Appendix 10_4

Please see below my letter of objection with supporting details to the proposed applications at Meadowbank View and Meadowbank Gardens, Wellbank for road Construction Consent. Ref 145271-1002-A_RCC Application Sht 2 Meadowbank View & 145271-1001-B_RCC Application Meadowbank Garden, received from Andrew Barnes, Team Leader – Traffic, Angus Council on the 15/11/21.

Figure 1

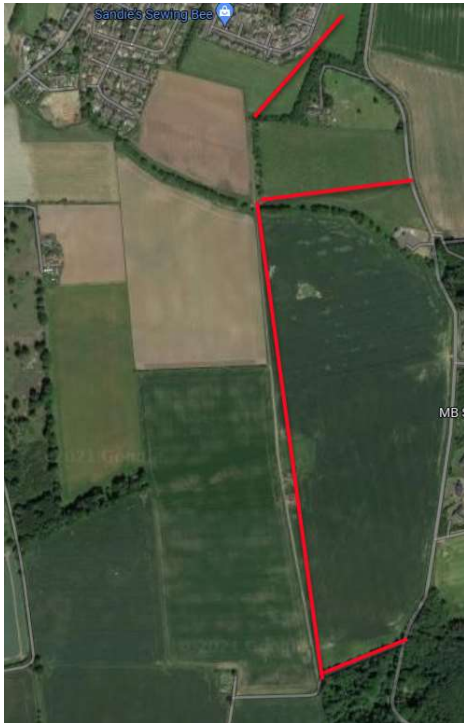
- The existing field has not been accessible through the village of Wellbank since the mid 1990's when the Meadowbank View and Gardens houses were constructed. Since that time access has been gained via the 3 routes shown in Fig 1 (on page 2) via existing farm tracks and crossing other fields. I'm not aware of any reason additional access routes would be required.

- To get to the 2 proposed new entrances, would require large agricultural machinery to be driven from the main B978 Kellas road, through Gagie Bank and into Meadowbank Gardens/View (shown in fig 3). This are is a solely residential area and the roads are small, have numerous tight turns and parked cars on them at all time. This makes it unsafe and unsuitable for large machinery to be using them especially when suitable alternatives are already available (shown in fig 1.)

- The village roads mentioned above roads are all used by the many local parents & children walking and cycling to the Mattocks primary school. It would be unsafe, dangerous, and unsuitable to have large, agricultural machinery sharing the same roads when suitable alternatives are already available (shown in fig 1.)

Figure 2

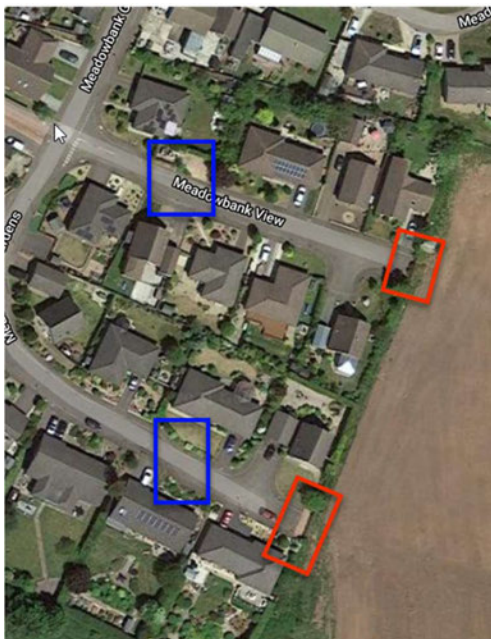
- Both Meadowbank View and Gardens are small residential cul-de-sacs and have sections of road where they narrow to single lane (shown in the blue boxes fig 2) which are unsuitable for large agricultural machinery when suitable alternatives are already available (shown in fig 1.)

- The applicant has requested 2 new accesses within 200m or each other on the same side of the field shown in the red boxes in fig 2 (at the end of this document) which seems excessive when suitable alternatives are already available as shown in fig 1.
